DSA CODE AMENDMENT DEVELOPMENT

Tracking	
Date Received:	-
DSA Tracking Number:	ITEM 1.01
Date Reviewed:	11/13/2018
Status:	Final Submittal

Applicable Code
Applicable Code Section(s): CBC Ch. 1, Sect. 1.9.1.1.3
Topic: Public housing

FIGURE 11B-813.2.1.2
CLEARANCE AROUND ADULT CHANGING TABLE

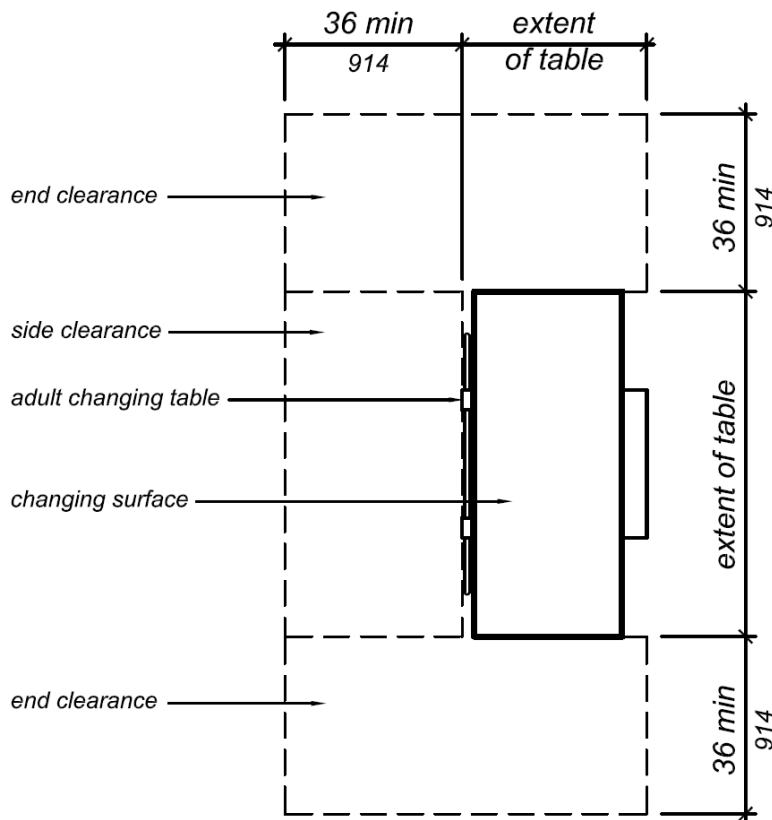
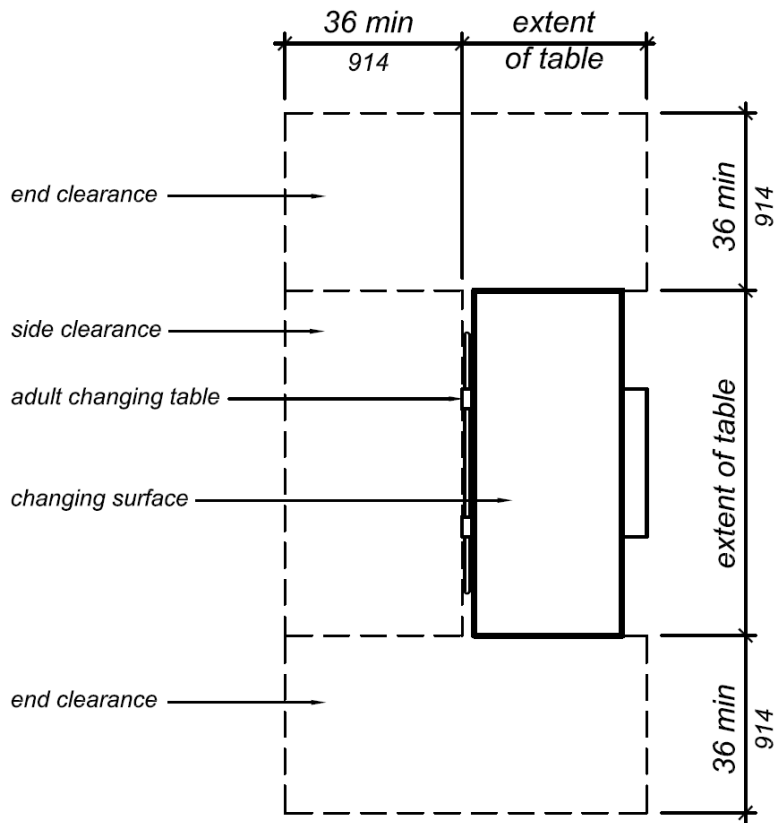
DSA-AC is proposing new definitions, scoping and technical accessibility code requirements for adult changing facilities in response to Assembly Bill 662 (2015-2016) / California Health & Safety Code §19952.5. Consistent with statute, this proposal requires an adult changing facility at newly constructed commercial places of public amusement, as defined. This proposal also provides specific requirements for other adult changing facilities that are optionally provided. DSA convened an Adult Changing Facility Task Force which met five times in 2017 to solicit input on the scoping and technical requirements for these facilities.

DSA Response to CAC: Accepted. DSA has additionally studied this item and confirms the proposed revision is appropriate for inclusion in the California Building Code; this includes use of the term “maximum occupancy.” The CAC made several additional suggestions to improve clarity of the language and DSA has amended the express terms to address these issues.

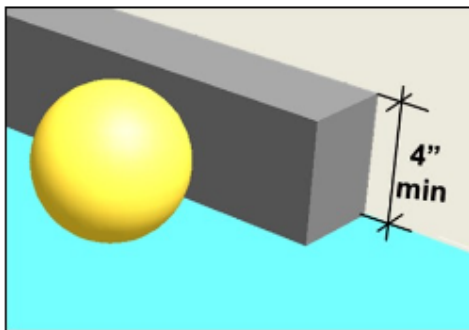
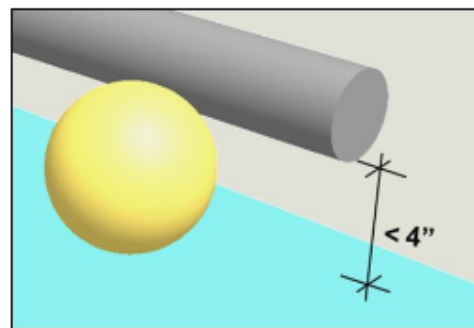
- 2010 ADA Standards:
405.9.2 Curb or Barrier. A curb or barrier shall be provided that prevents the passage of a 4 inch (100 mm) diameter sphere, where any portion of the sphere is within 4 inches (100 mm) of the finish floor or ground surface.
- From US Access Board's *Guide to the ADA Standards*:

Curbs if used must be at least 4" high.

Rails or other barriers must prevent passage of a 4" diameter sphere.

**FIGURE 11B-604.8.1.2
MANEUVERING SPACE WITH SIDE-OPENING DOOR**

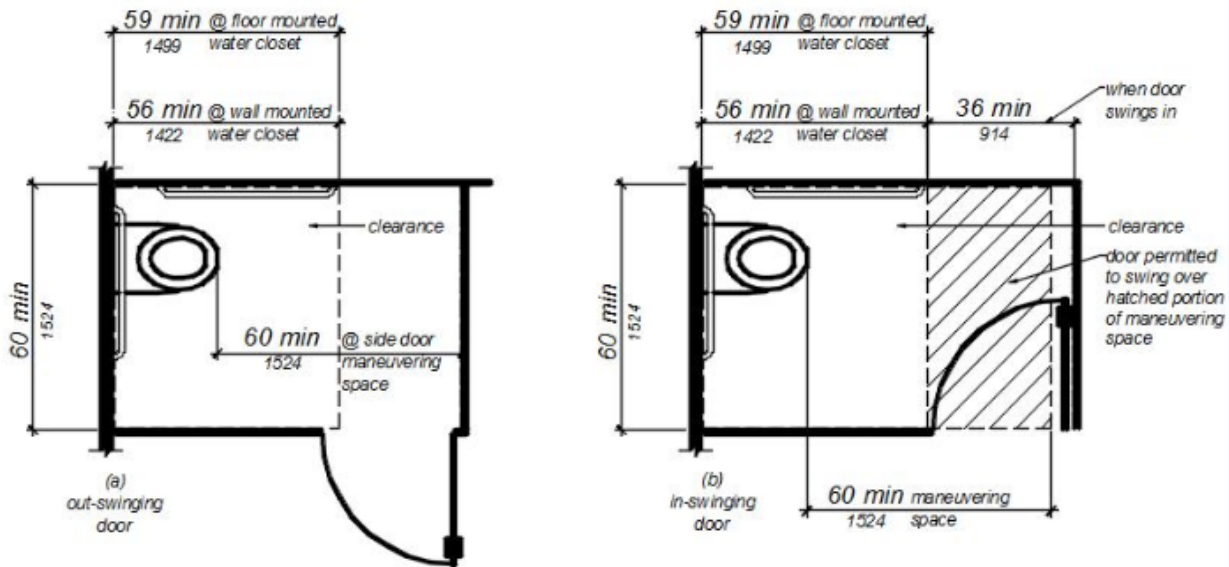
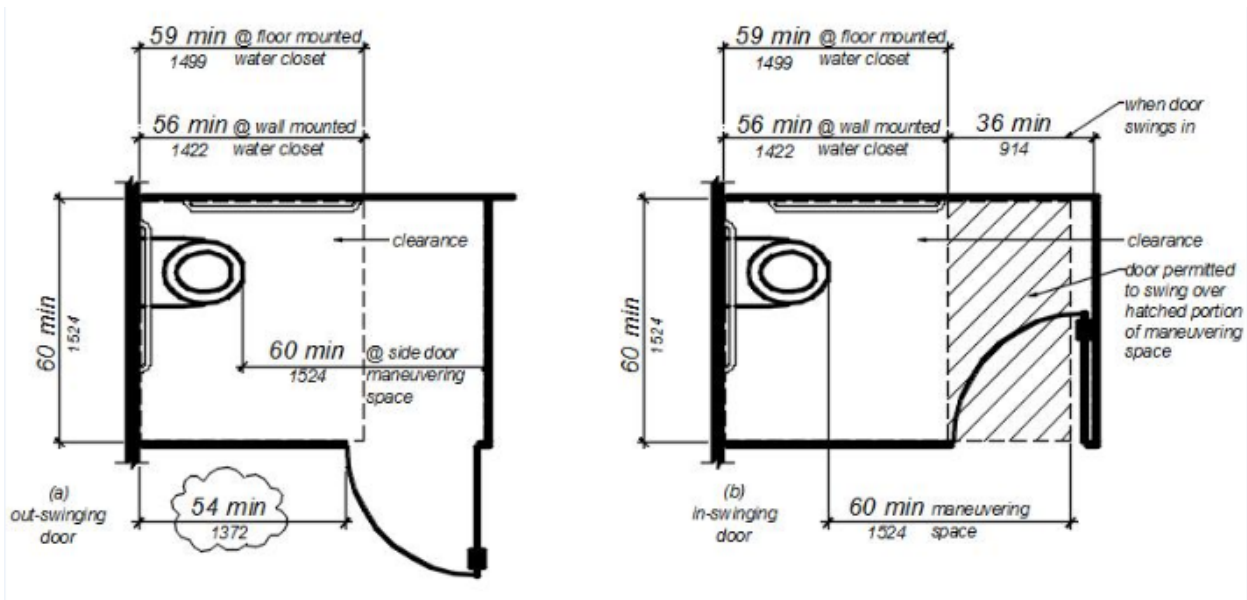
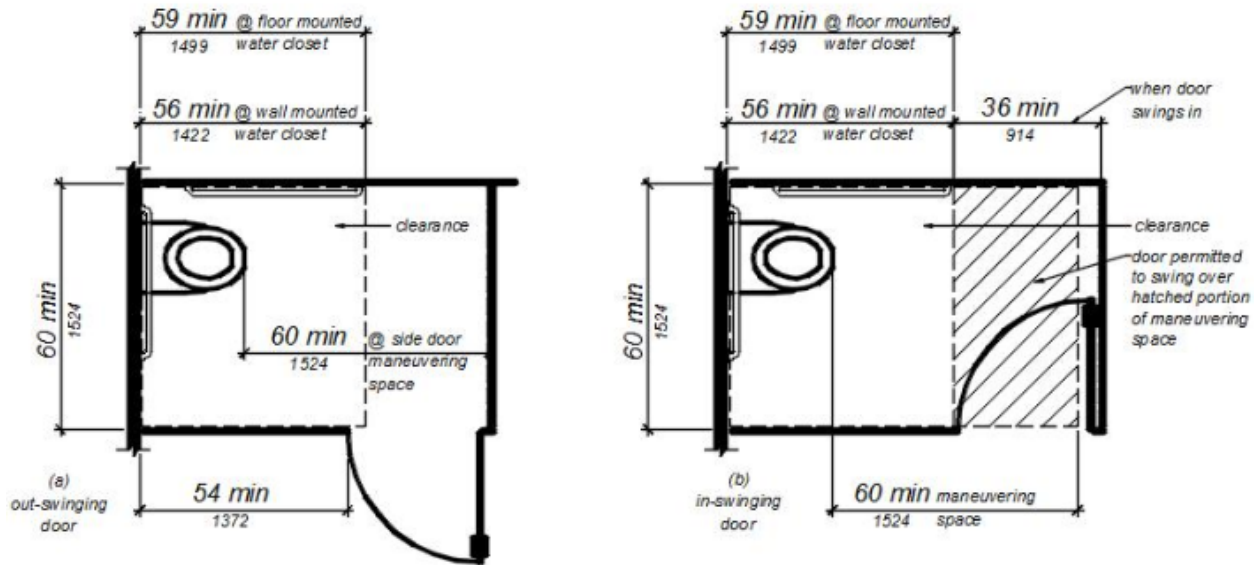
DSA-AC is proposing to amend Section 11B-604.8.1.2 and Figure 11B-604.8.1.2 to revise the required location for out-swinging toilet compartment doors in the side wall or partition of an accessible toilet compartment. The current provisions require the door to be 4 inches maximum from the front partition. This proposal allows the toilet compartment door to be located in a variety of locations in the side wall or partition while maintaining equal or greater accessibility than the current CBC Chapter 11B requirements and the 2010 ADA Standards for Accessible design.

DSA Response to CAC: Accepted.

FIGURE 11B-608.2.1 TRANSFER TYPE SHOWER COMPARTMENT SIZE AND CLEARANCE

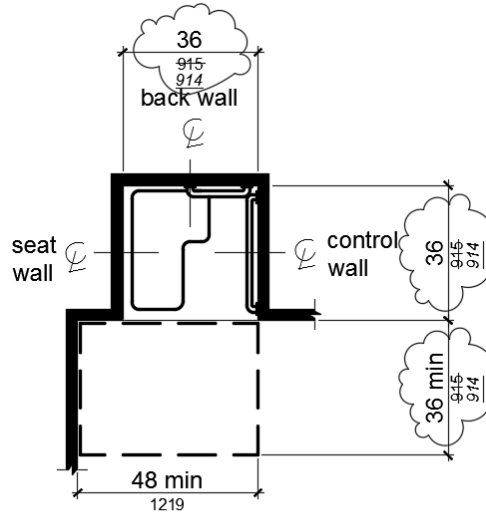
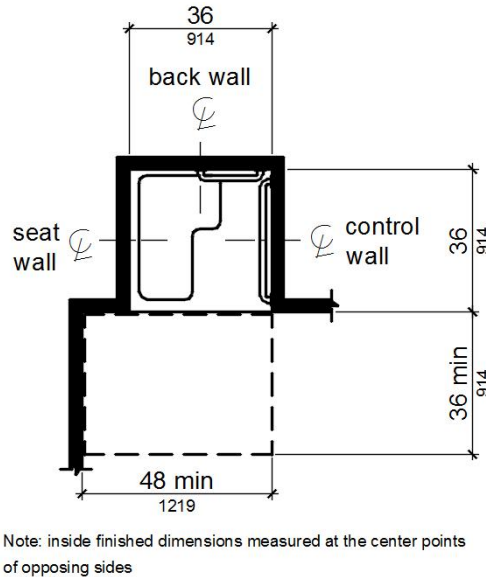
DSA is proposing this code change in response to users of mobility devices who prefer this type of shower stall. By not allowing the use of a transfer shower, in facilities regulated by Chapter 11B, persons with disabilities are denied an option that may better meet their needs. The transfer type shower stall allows for the mobility device to be placed outside of the wet area while using the shower compartment and provides for controls that are within reach range when seated. This amendment, if approved, will align the provisions for a transfer type shower compartment in Chapter 11B with the 2010 ADAS.

The provisions limiting the locations where transfer type shower compartments are permitted is in response to the comments of the Code Advisory Committee members for this item. A committee member asked if transfer type showers would be allowed in medical facility patient rooms. As proposed a roll-n shower is required where showers are provided in medical facility patient rooms.

DSA Response to CAC: Accepted. DSA has studied this item and has included scoping to clarify locations where transfer type shower compartments are allowed and where roll-in type showers are required.

FIGURE 11B-608.3.1 GRAB BARS FOR TRANSFER TYPE SHOWERS

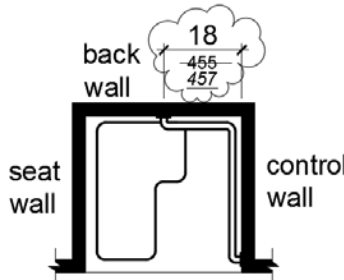
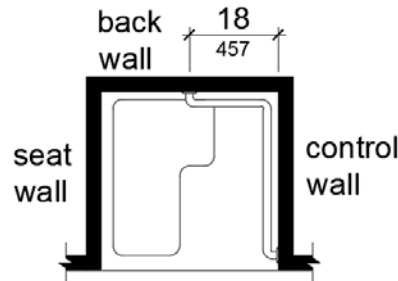
DSA is proposing this code change as a related amendment to Section 11B-608.2.1 to address the requirements for grab bars in transfer type showers.

DSA Response to CAC: Accepted. DSA has studied this code change proposal and has determined that an elevation is not necessary to illustrate the requirements for this code section. The comments made in reference to related sections have been studied and addressed.

**FIGURE 11B-608.5.1 TRANSFER TYPE
SHOWER COMPARTMENT CONTROL LOCATION**

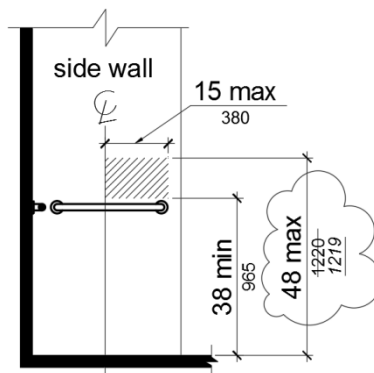
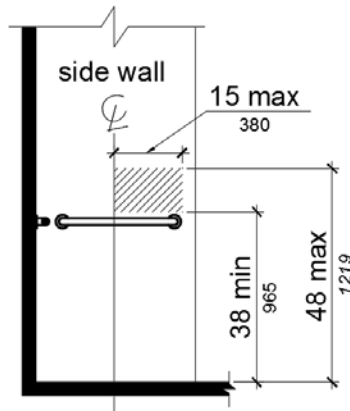
The second amendment DSA is proposing is related the code change proposal in Section 11B-608.2.1 to provide the requirements for controls in transfer type showers.

DSA Response to CAC: Accepted. DSA has determined, after further study, to retain the code change proposal with the location of the shower controls as written. The location of the shower controls as
